Access Compliance Report

Public Rights-of-Way

(Pedestrian Signals)

Intersection ID: N/A	Main Street:	Cross Street: N/A	Location: N/A
ADA ID: C6583788121A	Signal Type: One Push Button-APS	Overall Compliance: No	Severity Score: BTN 1: N/A BTN 2: N/A No BTN: N/A
Codes/Mitigation Info/Possible Solution		Field Measurements/Component Compliance

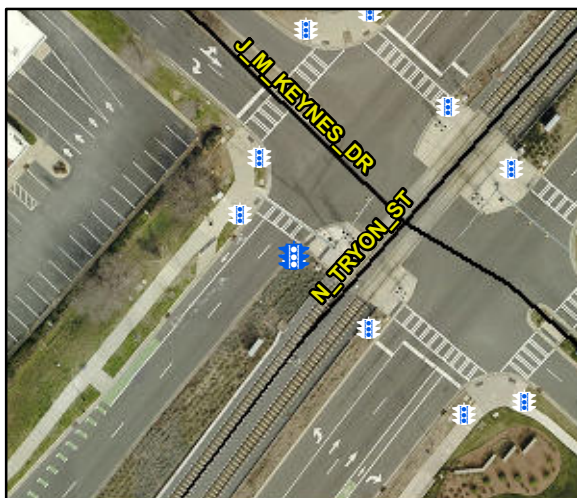
PROW/ADA: TMUTCD 4e.08, R404.3, R404.7.2, R209.1, MUTCD 4e.10

N/A	B 1 FWD Approach Width (in)	N/A	N/A	B 2 FWD Approach Width (in)	N/A
N/A	B 1 FWD Approach Obstruction?	Yes	N/A	B 2 FWD Approach Obstruction?	N/A
N/A	B 1 FWD Approach Obstruction Dist (in)	4.0	N/A	B 2 FWD Approach ObstructionDist (in)	N/A
N/A	B 1 PARA Approach?	Yes	N/A	B 2 PARA Approach?	N/A
N/A	B 1 PARA Approach Constrained?	Yes	N/A	B 2 PARA Approach Constrained?	N/A
Yes	B 1 PARA Approach Reach (in)	10.0	N/A	B 2 PARA Approach Reach (in)	N/A
No	B 1 PARA Approach Width (in)	48.0	N/A	B 2 PARA Approach Width (in)	N/A
N/A	B 1 PARA Approach Obstruction?	Yes	N/A	B 2 PARA Approach Obstruction?	N/A
N/A	B 1 PARA Approach Obstruction Dist (in)	4.0	N/A	B 2 PARA Approach ObstructionDist (in)	N/A
Yes	B 1 Clear Floor Space Slope (%)	0.9	N/A	B 2 Clear Floor Space Slope (%)	N/A
Yes	B 1 Clear Floor Space XSlope (%)	1.1	N/A	B 2 Clear Floor Space XSlope (%)	N/A
N/A	B 1 PAR Slope (%)	N/A	N/A	B 2 PAR Slope (%)	N/A
Yes	B 1 Height (in)	38.0	N/A	B 2 Height (in)	N/A

N/A	B 1 Clear Xing Direction?	Yes	N/A	B 2 Clear Xing Direction?	N/A
	B 1 Crossing Direction	To NW		B 2 Crossing Direction	N/A
Yes	B 1 DistanceTo XWalk (in)	8.0	N/A	B 2 DistanceTo XWalk (in)	N/A
No	B 1 DistanceTo Curb (in)	3.0	N/A	B 2 DistanceTo Curb (in)	N/A
Yes	B 1 Diameter (in)	2.0	N/A	B 2 Diameter (in)	N/A

Possible Solutions: Replace Signal Push Button With APS Button on New Post. Remove & Relocate Sign.
